## Memorandum

Re: Further Information Response Part 1 – Bendigo-Ophir Gold Project Fast-track Application

**Figure 1: Shepherds Creek Potential Cofferdam Locations**

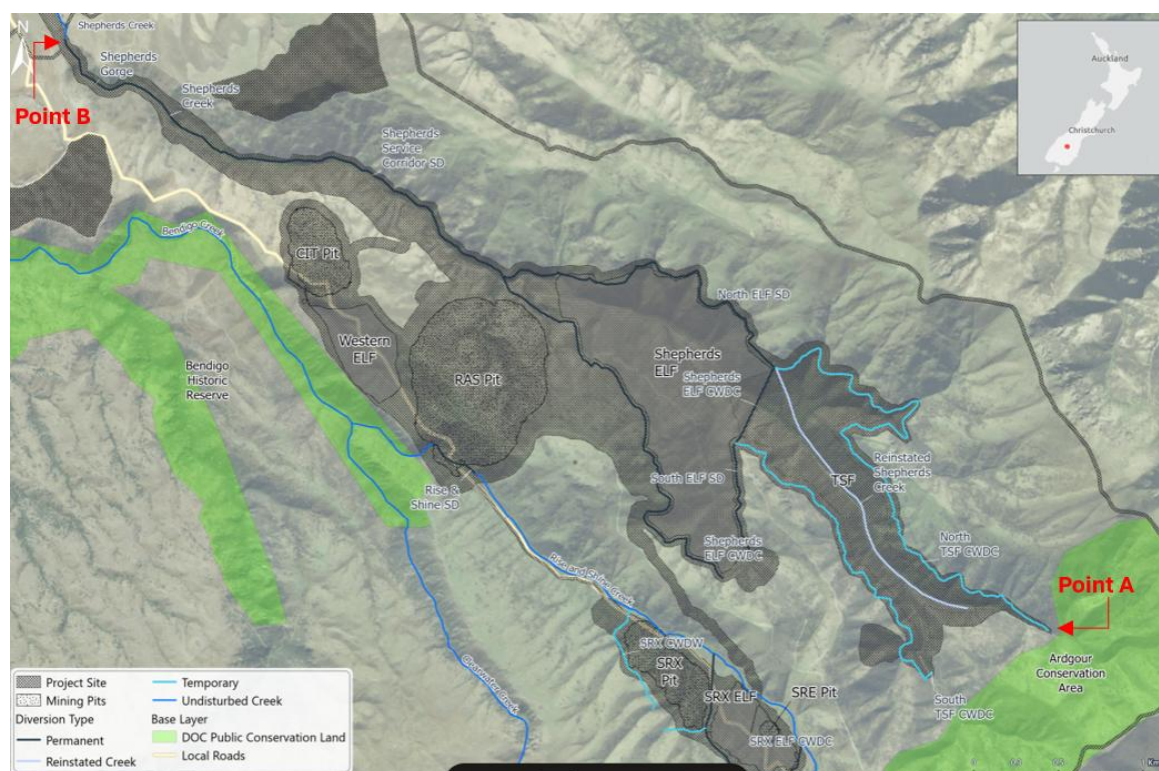
- 1. Please provide NZTM2000 coordinates and / or a map to show the approximate location of any culverts or other instream structures that are proposed to be installed within watercourses on the site. A land use consent has been sought to install four culverts in the beds of Shepherds Creek and Rise and Shine Creek, as well as flow control devices and coffer dams but only the culvert in Rise and Shine Creek has been identified.*

With respect to cofferdams, an initial cofferdam is proposed that will form the starter embankment for the Shepherds Tailings Storage Facility. This is shown in *B.21 Shepherds Tailings Storage Facility Technical Report* (Figure 14 – Starter Embankment Layout) at approximately NZTM E1319731 N5017166. In addition, the proposed reclamation of approximately 3.1 km length of Shepherds Creek to establish the Shepherds Service corridor will effectively result in the diversion of Shepherds Creek at various stages from above the TSF and down to the processing plant area. This will involve the placement of several sequential cofferdams in the bed of Shepherds Creek. While the specific locations cannot be determined until detailed design they will generally be placed between E1321610 and N5015739 at the uppermost point of the TSF (Point A) and E1315592 N5019299 below the process plant area (Point B). These locations are illustrated in Figure 1 below.
